STAFF RECOMMENDATION
1209 Paris Avenue
July 19, 2017

Application: New construction—outbuilding/detached accessory dwelling unit
District: Belmont Hillsboro Neighborhood Conservation Zoning Overlay
Council District: 18
Map and Parcel Number: 11801007800
Applicant: Kaitlyn Smous, Nine12 Design
Project Lead: Melissa Baldock, melissa.baldock@nashville.gov

Figure 1. 1209 Paris Avenue

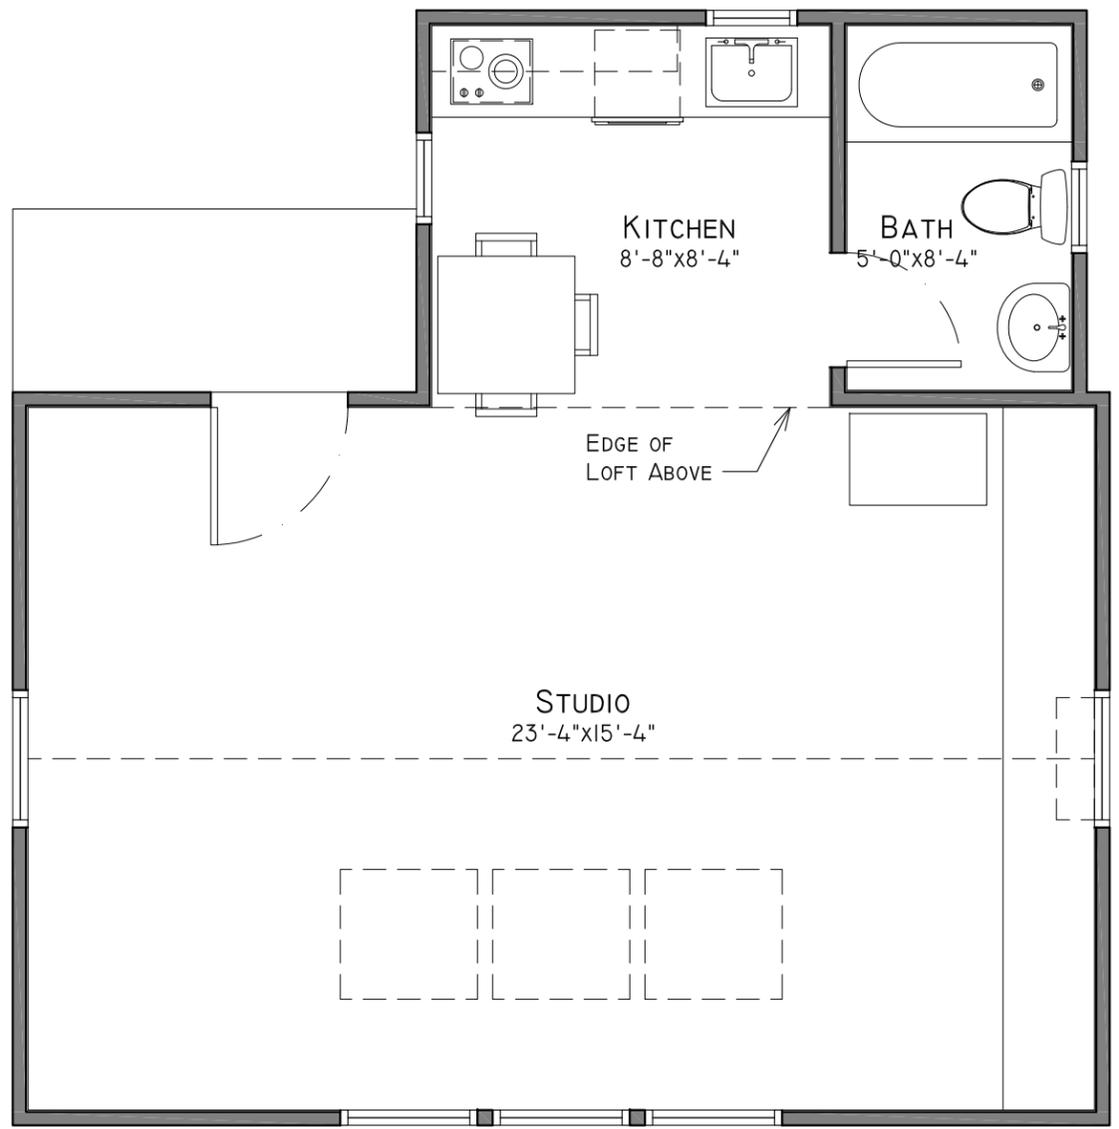
Background: 1209 Paris Avenue is a c. 1918 two-story historic house that contributes to the historic character of the Belmont-Hillsboro Neighborhood Conservation Zoning Overlay (Figure 1). In 2013, MHZC issued a preservation permit for a rear addition to the house.
